PRLIMINARY PLAT
GREEN MEADOW VILLAS
291 WEST MAIN STREET
PLANNING COMMISSION MEETING
OCTOBER 8, 2015

GREEN MEADOW VILLAS PUD
PRELIMINARY PLAT

Fencing:

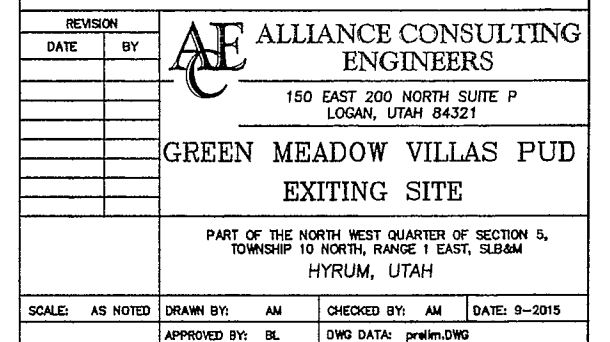
Privacy Fence is to be installed around the perimeter of development. You may want to talk about the fence on the South. Do you want to see a long privacy fence from the highway down that side? Would a different type of fence look better on that side? If you go with a privacy fence down the South it probably is going to need some extra landscaping along the highway to break it up.

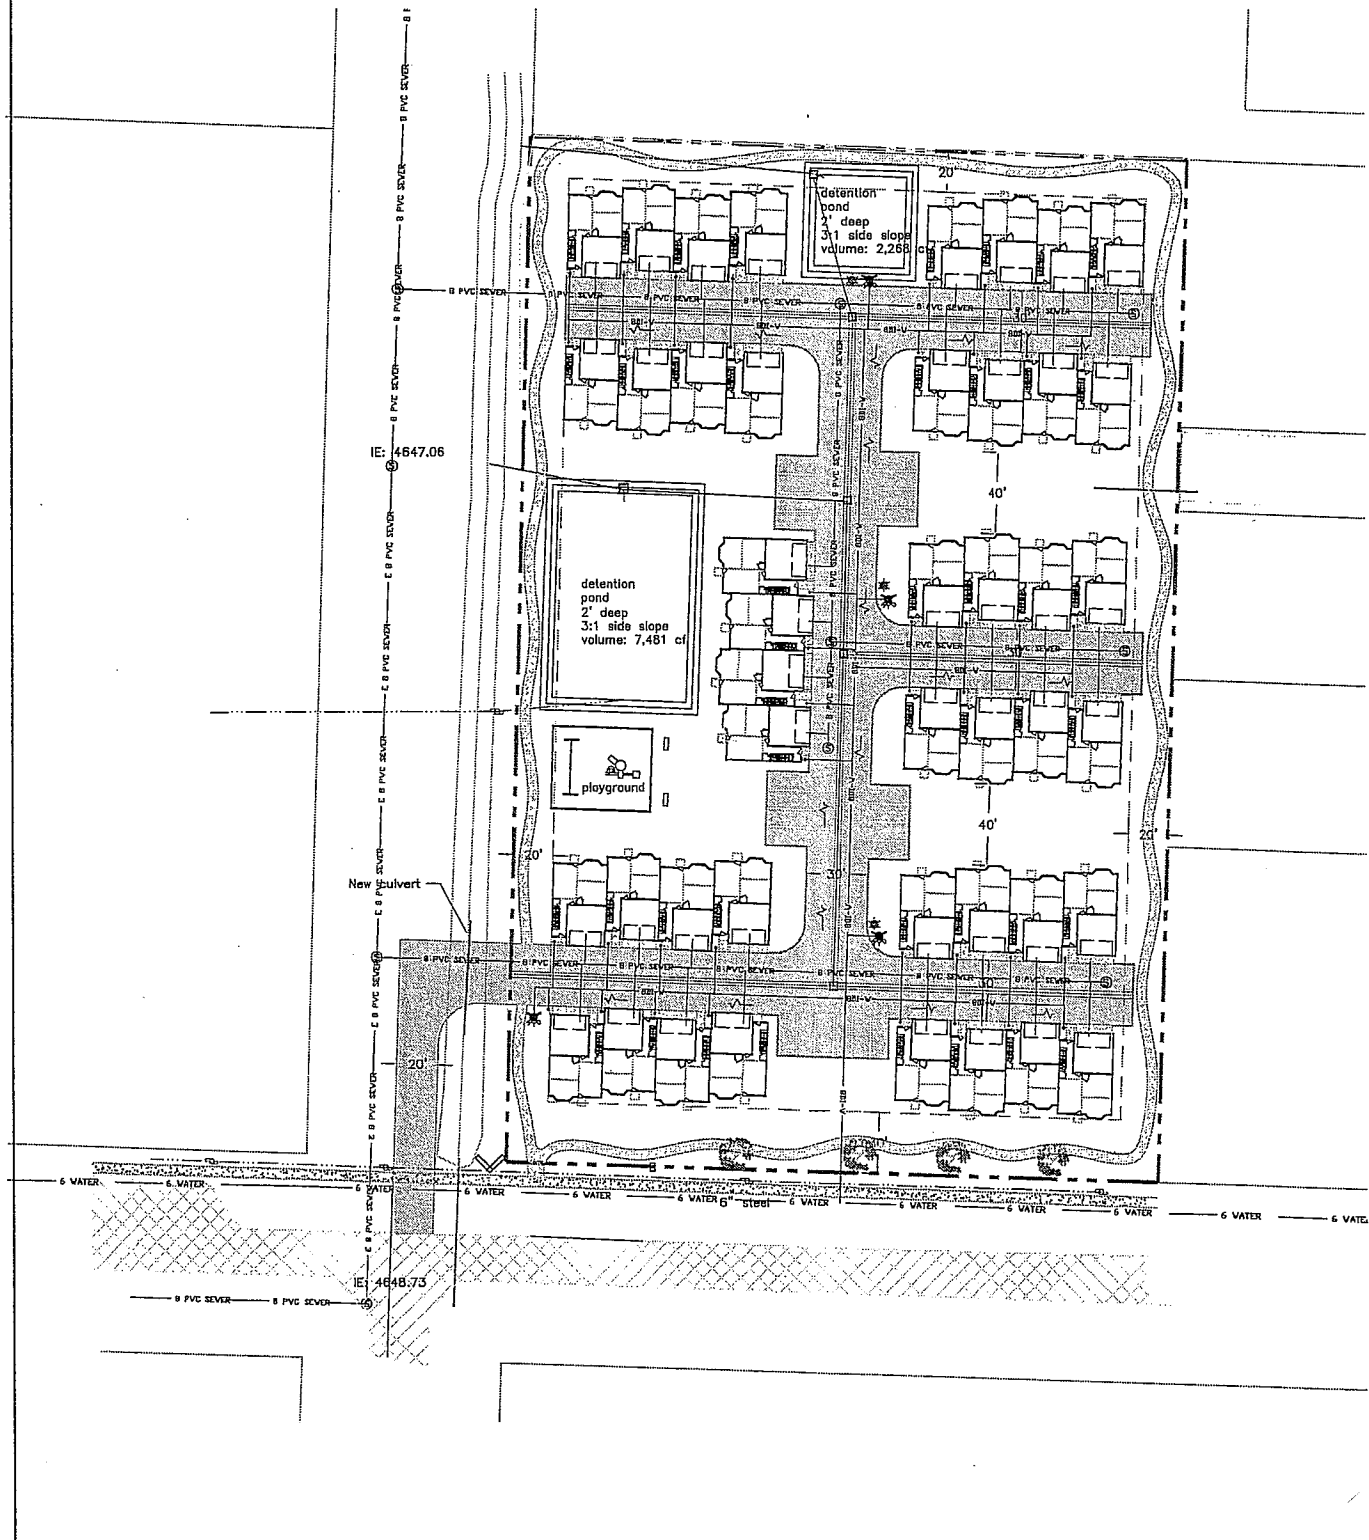
These will be private roads within the development. They have met with UDOT on the access. UDOT would like the access to line up with the storage unit access on the other side. They may need a right turn lane added for this development and that would be very difficult if the access was further to the East with the slope issues. The city staff believes this is a better location also for the access and sees no problem with them building the East half of the (20 ft asphalt) road were 300 West would be. They should curb and gutter the East side of that road if possible. They will need to have final approval from UDOT before the final plat is approved.

They will be building two detention ponds. They had been asked to flip the playground area to the East side of the property. That would create a drainage problem because the property slopes to the west so it makes more sense to keep the pond and playground area on the West side of the property. They will also need to continue the drainage pipe to the West side of the property as shown.

Creating a concrete walking trail around the perimeter of this development is a great feature. They also will need to show a sidewalk going to Salt Hollow Park. They were waiting for some more input from the city staff on this. The staff is recommending it be a concrete sidewalk. They will need to create a good base for the sidewalk but it can be done. They would build this on city property were 300 West is shown. You may want to discuss the playground and give some definite requirements of what you expect there. (Slide, swing, sandbox, &?)
